Cogentrix Quail Brush Generation Project - Docket Number 11-AFC-3, Initial Response to CEC's Data Requests, 94 through 95

**Re: Quail Brush Generation Project (11-AFC-03)
Initial Response to CEC's Data Requests, 94 through 95**

Figure 1 – Nearest Kumeyaay Campground Campsite to the Quail Brush Generation Project

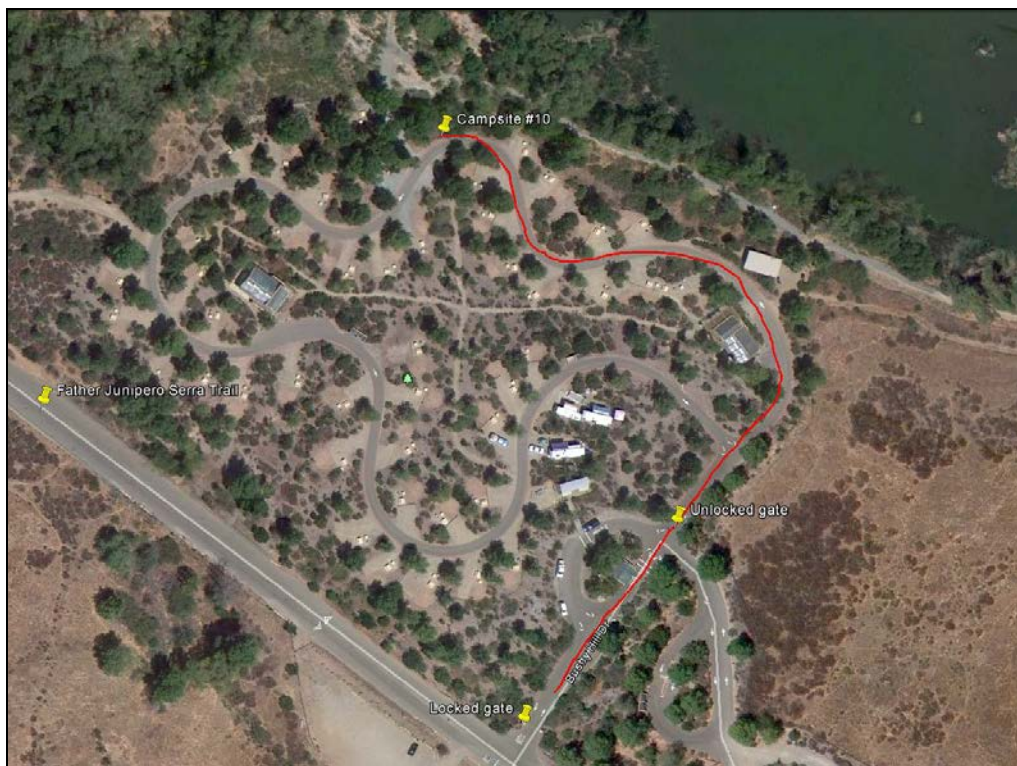
94. Provide noise measurements of the existing ambient noise levels at Kumeyaay Campground. As requested, measurement of existing ambient sound levels at the Kumeyaay Campground is planned. The survey will include continuous measurements from 10:00 pm to 7:00 am. The measurements are planned to be collected on a Saturday and a weekday from an available campsite that is closest to the proposed Project. Campsite #10 is the closest campsite to the proposed Project, which was identified by Matt Sanford, Senior Park Ranger with the City of San Diego (please refer to Figure 1).

Measurement results will be reported in terms of the sound metrics requested by the CEC: L_{eq} , L_{10} , L_{50} , L_{90} , L_{min} and L_{max} . In addition, a one-hour measurement during mid-morning, mid-afternoon and evening periods will be collected. The ambient data will be analyzed and the Project's modeled noise levels at the Kumeyaay Campground during construction, operation, and nighttime plant activities will be calculated. Tetra Tech will compile the results of the survey and report potential impacts at the Kumeyaay Campground as a result of the Project.

In consideration of Project schedule, Tetra Tech is proposing to conduct the ambient sound measurements on Saturday, December 1st and a weekday prior to or after this date. The survey is not being conducted earlier than December 1st due to Thanksgiving and the atypical traffic that could occur as a result of people traveling for the holiday.
